Access Compliance Report

Public Rights-of-Way

Intersection ID: 10031405	Main Street: MCALPINE_PARK_DR	Cross Street: N/A	Location: SW
ADA ID: 90533967988F	Ramp Type: BlendTrans2	Initial Pass/Fail: Fail	Overall Compliance: No
Severity Score: 42.5			
Codes/Mitigation Info/Possible Solution		Field Measurements/Component Compliance

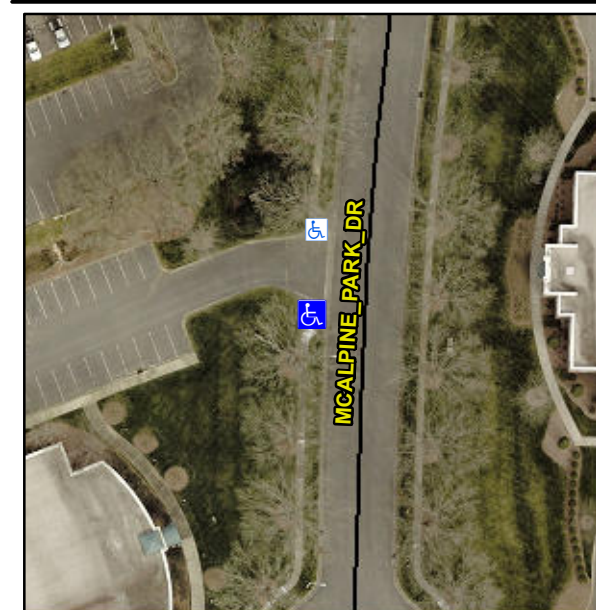
R304.5.1, R304.5.3

Compliance	Description	Data	Compliance	Description	Data
N/A	Ramp Length (in)	110.0	Yes	BlendTrans Slope (%)	3.1
No	Ramp Width (in)	32.0	No	BlendTrans XSlope (%)	7.4
N/A	Flare Type LT	N/A	N/A	Flare Type RT	N/A
N/A	Flare Slope LT (%)	N/A	N/A	Flare Slope RT (%)	N/A
N/A	Flare Traversable LT?	N/A	N/A	Flare Traversable RT?	N/A
N/A	Landing Length (in)	N/A	N/A	DWS Provided?	N/A
N/A	Landing Width (in)	N/A	N/A	DWS Contrast?	N/A
N/A	Landing Slope (%)	N/A	N/A	DWS Length (in)	N/A
N/A	Landing X Slope (%)	N/A	N/A	DWS Full Width?	N/A
N/A	Landing Curb? (Y/N)	N/A	N/A	DWS Offset (in)	N/A
N/A	Shared Landing?	N/A			
N/A	Gutter Ponding?	N/A	N/A	Gutter Slope (%)	N/A
N/A	Gutter Lip Ht (in)	N/A	N/A	Gutter X Slope (%)	N/A
N/A	Painted X Walk1?	No	N/A	Painted X Walk2?	No
	X Walk 1 Direction	To E		X Walk 2 Direction	To N
	X Walk 1 Width (in)	N/A		X Walk 2 Width (in)	N/A
	X Walk 1 Slope (%)	4.1		X Walk 2 Slope (%)	5.1
	X Walk 1 X Slope (%)	2.9		X Walk 2 X Slope (%)	6.4

Remove & Replace Curb Ramp With Two New Directional Ramps or Equivalent.
